Economic Commission for Europe
Inland Transport Committee
World Forum for Harmonization of Vehicle Regulations
Working Party on Brakes and Running Gear
Eightieth session

Geneva, 15–18 September 2015

**Report of the Working Party on Brakes and Running Gear
on its eightieth session**
Contents

Figure 25 a

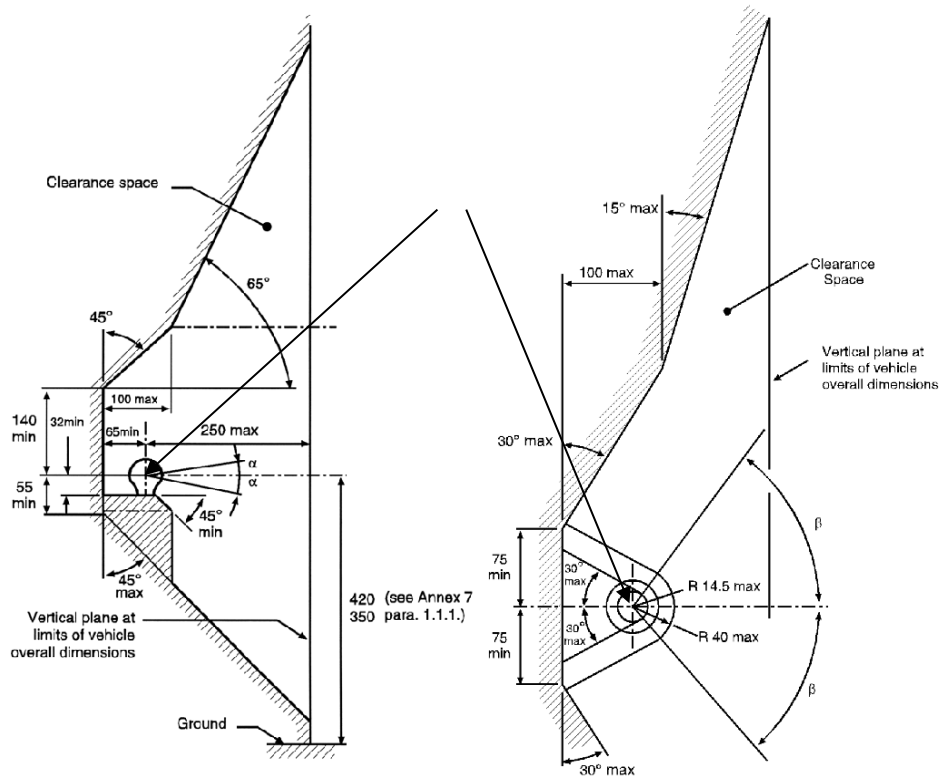
1.1.1. Coupling balls, **hook coupling** and towing brackets shall be attached to vehicles of categories M₁, M₂ (below 3.5t maximum permissible mass) and N1 1/ in a manner which conforms to the clearance and height dimensions given in Figure 25. The height shall be measured at the vehicle loading conditions given in appendix 1 to this annex.

1.1.1.1. The clearance space shown in Figures 25a and 25b may be occupied by non-demountable equipment, such as a spare wheel, provided that the distance from the **centre** of the ball **or the centre of the hook** on a vertical plane at the extreme rearmost point of the equipment does not exceed ~~300 mm~~ **250 mm**. The equipment shall be mounted to allow adequate access for coupling and uncoupling without risk of injury to the user and without affecting articulation of the coupling.

is rotated horizontally 60° to right or left, ($\beta = 60^\circ$, see Figure 25);

is rotated vertically 10° up or down ($\alpha = 10^\circ$, see Figure 25);
